# ***Wellington Solar Farm (Mod 1)***

*State Significant  
Development  
Modification Assessment  
(SSD 8573 MOD 1)*

December 2019

**Figure 2** | Proposed Modification

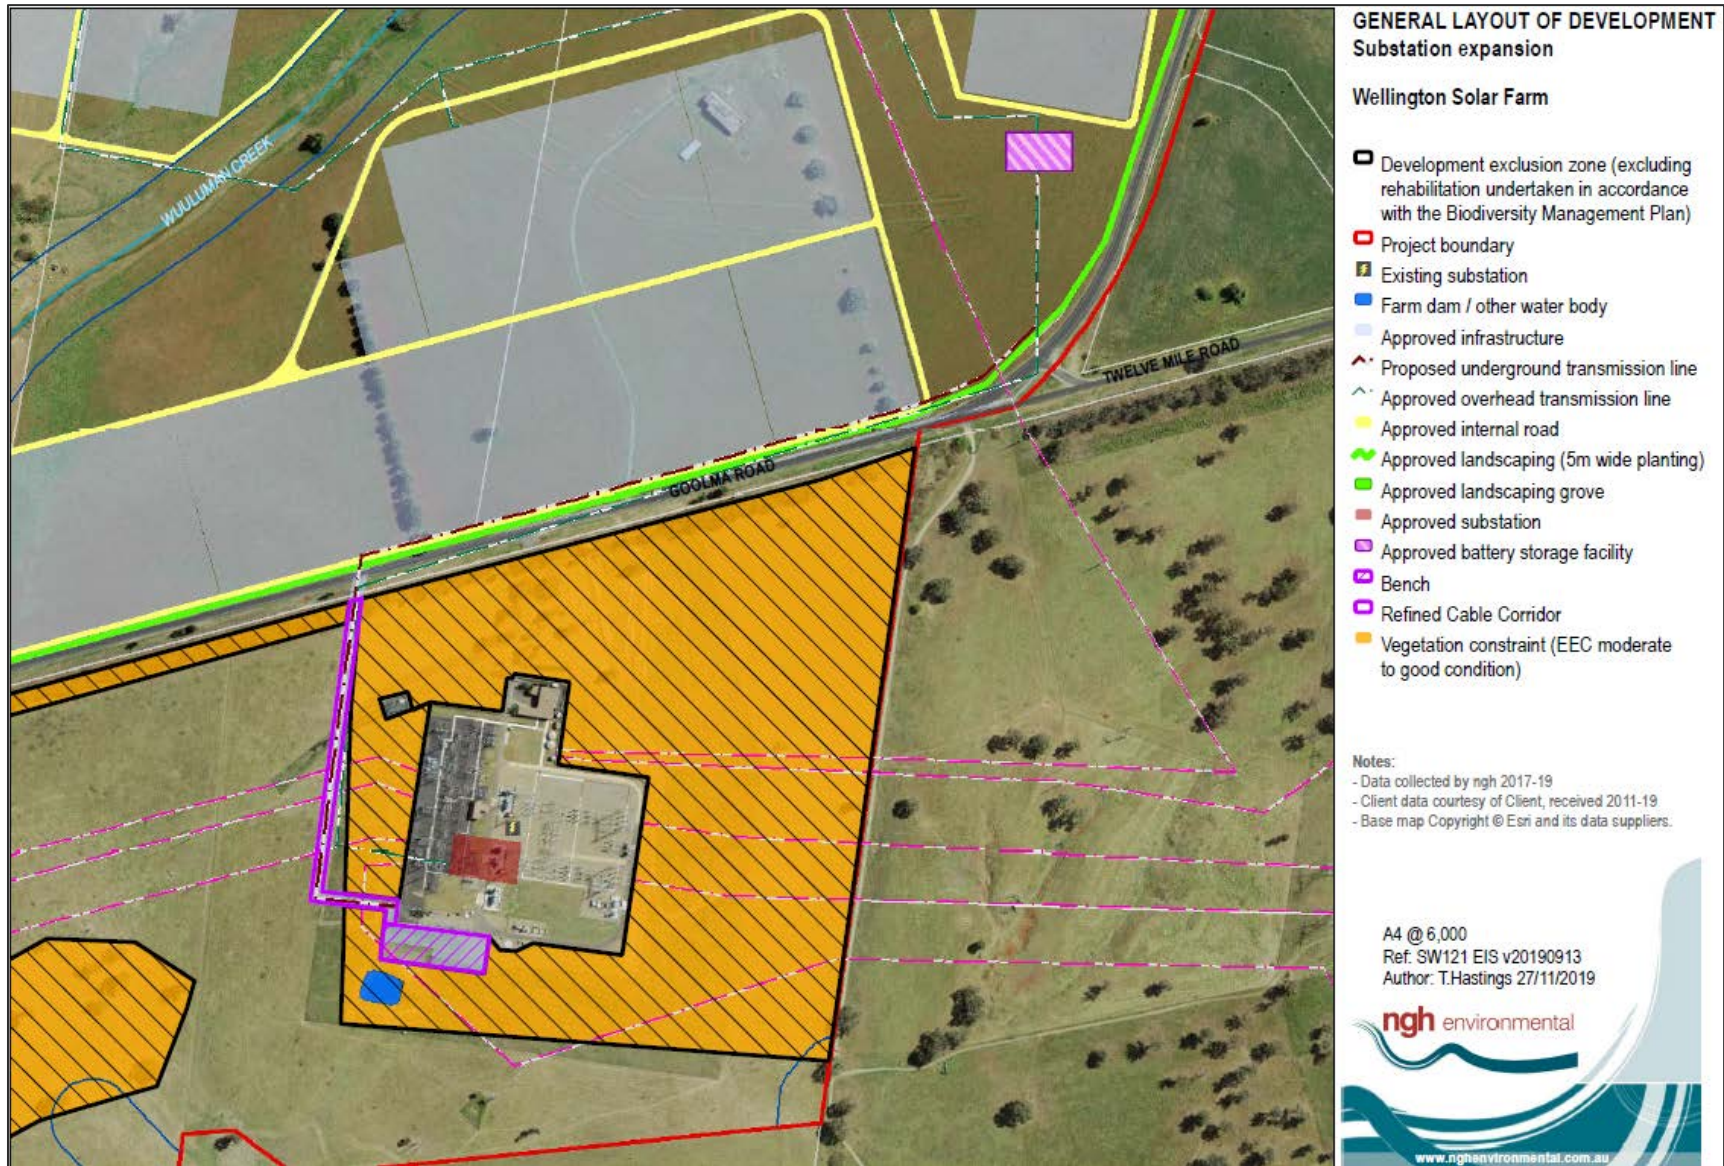
The proposed underground transmission line generally follows the alignment of the approved overhead line. However, the proposed underground line would run parallel to Goolma Road underneath an internal access road within the development footprint (as opposed to within the Goolma Road road reserve), before it crosses Goolma Road towards to substation.

South of Goolma Road the underground transmission line would follow the approved overhead line alignment but would extend by approximately 110 m (i.e. the length between the approved and proposed connection points).

Despite this extension, the proposed underground transmission line would be longer by approximately 5 m (i.e. 1,275 m). The difference is due to the proposed realignment between the energy storage facility and the crossing of Goolma Road, which would make this section of the proposed transmission line shorter.

**Figure 4** | Vegetation Community Zones within the Proposed Modification

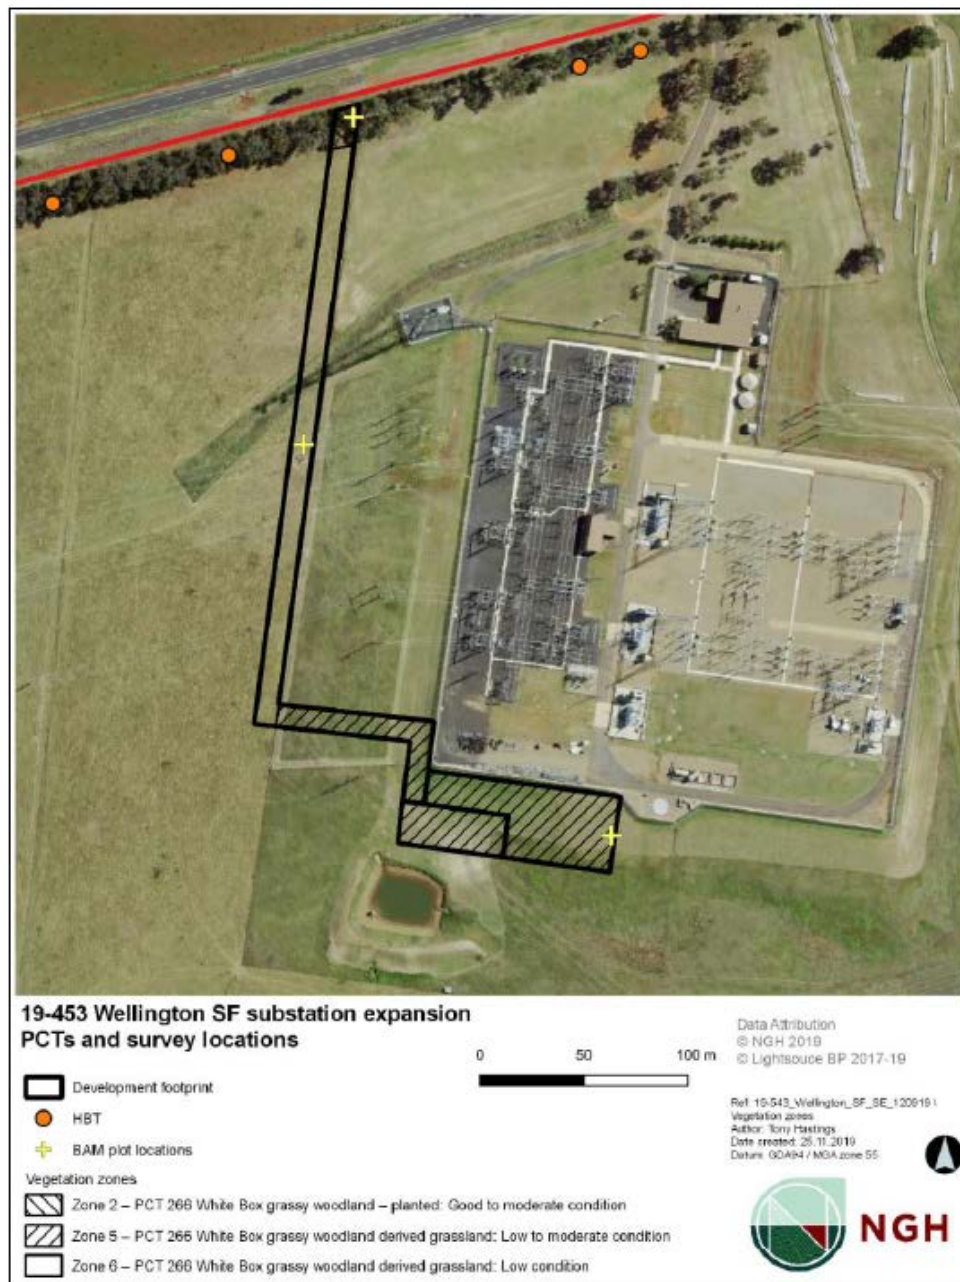
designed to minimise the impacts to native vegetation, it would still impact 0.78 ha, including 0.02 ha of EEC in moderate to good condition. The impacts to each zone are specified in **Table 1** and **Figure 4**.

Under the NSW Biodiversity Offsets Scheme, the clearing of EEC in moderate to good condition (zone 2) would increase the project's offset requirements by an additional ecosystem credit (from 3 as originally approved to 4 required after this modification). The impacts to the other two zones (zone 5 and zone 6) would not generate any additional ecosystem credits due to the low condition of the vegetation.

In addition, the entire area of impact (0.78 ha) has been assessed as suitable habitat for the Pink-Tailed Legless Lizard which is a threatened species under the BC Act. Although a fauna survey was not undertaken, the species was assumed to be present. Therefore, this resulted in two species credits (meaning a total of two species credits is now required for the project).

Both the Department and the BCD are satisfied that the modification would not result in any significant biodiversity impacts, subject to the provision of the updated offset liability credits.
